PLAN SNAPSHOT REPORT BBA24-0006 FOR THE CITY OF ANN ARBOR

Description: BLDGC23-0336 – Inspection Comment, Venting of Fixture Drains

Verve Ann Arbor/Forest Ave project,

1 BOXOUT PIPING - CURRENT

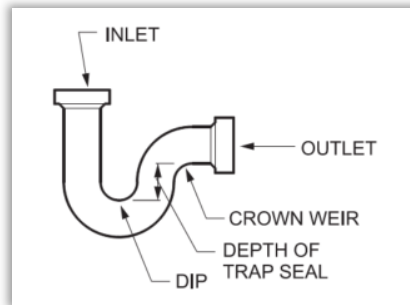
During a recent plumbing inspection, the plumbing inspector cited an issue with the waste piping coming from the shower drains at level 2 of the building. The level 2 concrete slab is a post-tension concrete transfer slab that has slab thicknesses of 24"-36". In the installation, a horizontal wet vent system is used to serve the bathroom group. Box outs in the level 2 slab have been provided to allow the shower trap to be within 24" of the discharge of the fixture, but then uses 22-1/2 degree elbows to offset below the slab before connecting to the horizontal wet vent of the bathroom group. The section cited by the inspector was 909.2 Venting of Fixture Drains (see snip below), of the 2018 Michigan Plumbing Code; due to the offset below the slab causing the total slope to exceed the diameter of the fixture drain.

Due to the presence of the post-tension cables and the thickness of the level 2 slab, we are not able to meet the requirements of section 909.2 while simultaneously meeting the requirements of section 1002.1 to not exceed a vertical distance of 24" from the fixture outlet to the trap weir.

2 BOXOUT PIPING - PROPOSED

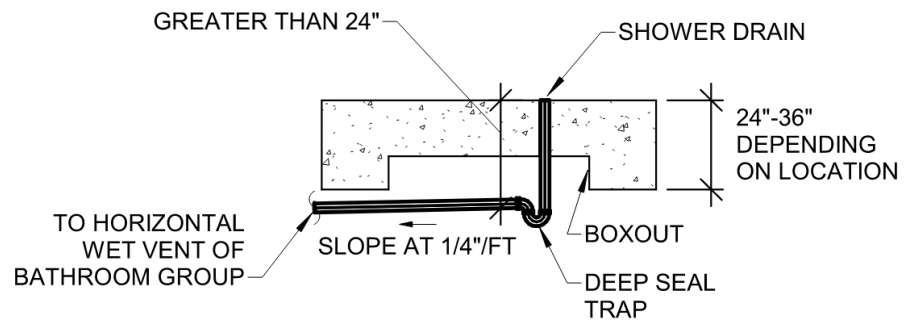
To best resolve this and meet the intent of the code, we are requesting a variance from section 1002.1 to exceed the 24" dimension listed by lowering the trap further so that the requirements of section 909.2 are achieved and the total slope from trap to vent does not exceed the diameter of the fixture drain. Additionally, we are proposing to increase the depth of the trap seal from 2" to 4", as allowed by section 1002.4. The increased depth of the trap seal along with the oversized piping from the shower (2" versus the minimum 1-1/2") will assist in alleviating the potential for self-siphoning of the trap. The nature of a shower fixture also allows for "trailing water" after turning off the showerhead, which continues to drain smaller amounts of water to replenish the trap in the unlikely event that the trap seal was depleted by a self-siphon event.
